ENGINEERING CHANGE NOTICE

Originator: _____ Phone No. _____ Email Address: _____ Department _____	Reza Esmaeili	Date:	Document Number
	(416) 754-3322	March 24, 2020	ECN20200324-00
	resmaeili@edac.net	ECN Revision Number	SHEET
	ENGINEERING	1	1 of 3
		Part Number	Dwg Revision Number
		690-W05-290-483	9

WATERPROOF MICRO USB 5P(F) SMT TYPE

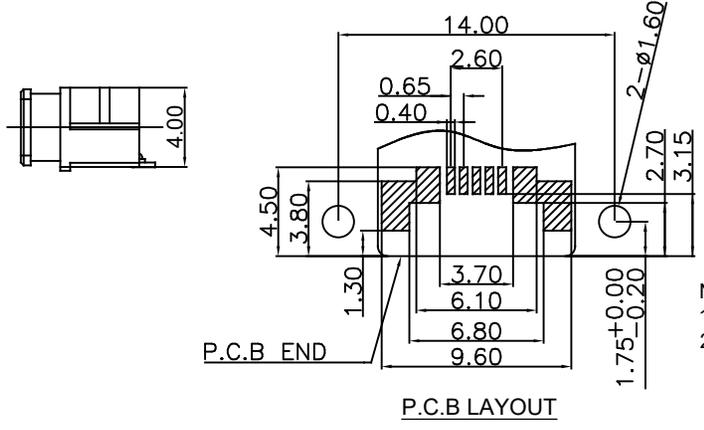
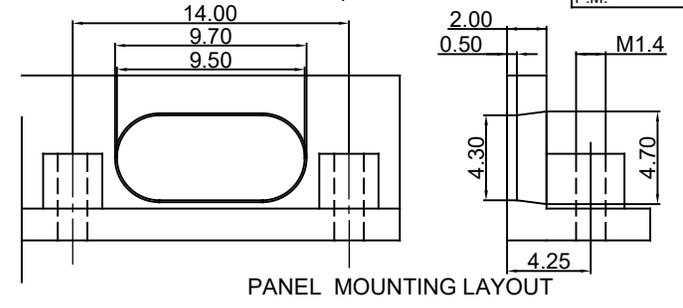
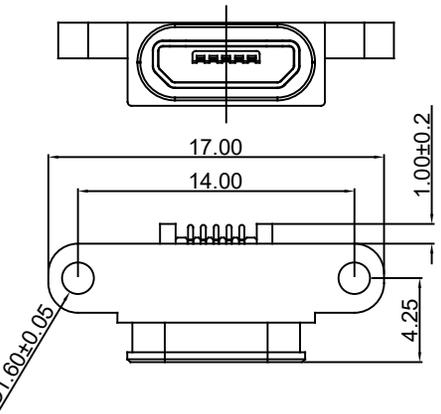
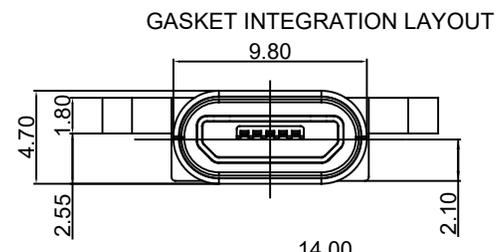
Clear Silicone (Rev 8) replaced by pre-heated Black Epoxy (Rev 9)
Also Epoxy retention force of minimum 20 Kgf has been added on the drawing

ISSUE NUMBER	
UPDATE GASKET TO SINGLE POINT O-RING R.STA.MONICA	SEPT.26/2016 (5)
ADD SILICON SE 9186 & ELECTRICAL SPECS Y.ZHANG	SEP.18/2018 (6)
UPDATE PCB LAYOUT	(7)
P.M.	OCT. 16/2018
ADD O-RING DETAIL UPDATE NOTE	(8)
P.M.	NOV. 11/2019
BLACK EPOXY WAS SILICON ADD EPOXY RETENTION FORCE	(9)
P.M.	MAR. 23/2020

- OPERATING TEMPERATURE: -40°C~+85°C
- MATERIALS:
 INSULATOR: LCP, UL94 V-0, COLOR: BLACK
 CONTACT: PHOSPHOR BRONZE, WITH 10µ" GOLD PLATING ON CONTACT AREA, AND GOLD FLASH ON SOLDER AREA OVER 50µ" NICKEL UNDERPLATING
 SHELL: STAINLESS STEEL, WITH MATTE TIN PLATING
 PAD: BRASS, WITH MATTE TIN PLATING
 O-RING: SILICON, BLACK
- MATCH WITH O-RING PART NO. M00-556-001 IS PACKED SEPARATELY.
- PART NO:**
 690-W05-290-483
 690-W05-290-783
- ELECTRICAL SPECS:**
 CURRENT RATING: 1.8A (PIN1 & PIN5) 0.5A (ONLY PIN2 & PIN3 & PIN4)
 VOLTAGE RAYING: 30V
 CONTACT RESISTANCE: 30mΩ MAX.
 INSULATION RESISTANCE: 100MΩ MIN. AT 500V DC
 DIELECTRIC WITHSTANDING VOLTAGE: 100V AC FOR 60s AT 10mA
- WATERPROOF RATING: IPX7
- EPOXY RETENTION FORCE: 20kgf Min.
